Property Location & Assessor's Parcel Numbers:	845 Embarcadero (Development of Parcel B) 018 046500219
Proposal:	To construct a residential and commercial mixed-use development for an 8-story, 241 residential unit with a ground-level retail area of approximately 3,000 square feet and parking garage on a 1.54 acres vacant lot. The site is located in Parcel B of the Final Development Plan for the Brooklyn Basin. <i>NOTE: On June 22, 2016, the Design Review Committee reviewed this application and recommended the applicant to make design modifications to the project. The Committee asked the applicant to return to the Design Review Committee meeting for further review.</i>
Applicant/ Phone Number:	Deborah Tu / (510) 251-9284 or (510) 251-9270
Property Owner:	ZOHP-1, LLC
Case File Number:	PUD06010-PUDF03
Planning Permits Required:	Regular Design Review for new construction.
General & Estuary Plan:	Planned Waterfront Development-1

PROJECT SUMMARY

PUD06010-PUDF03
845 Embarcadero
Brooklyn Basin

PERSPECTIVE VIEW
LOOKING AT RETAIL ENTRY AT SOUTH EAST CORNER

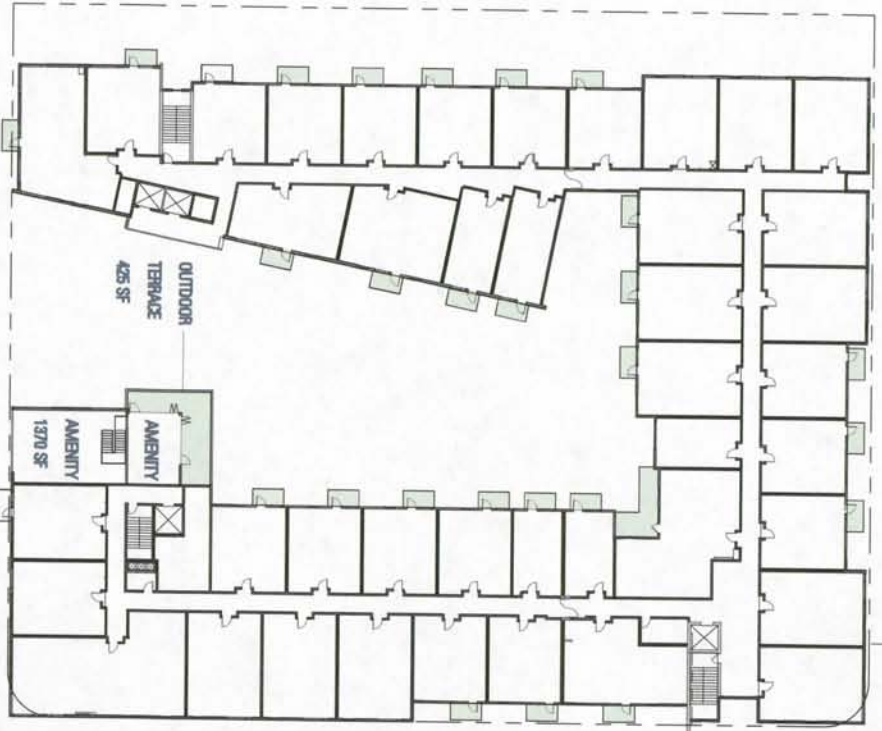
Applicant's response:

"The retail entry has been moved from Clinton Lane 9th Avenue and the entry on 9th avenue has been set back as identified on sheet 6 and illustrated in the perspectives on sheets 8 & 9. The ultimate entry location, set back, and use will be dictated by the requirements of the future tenant."
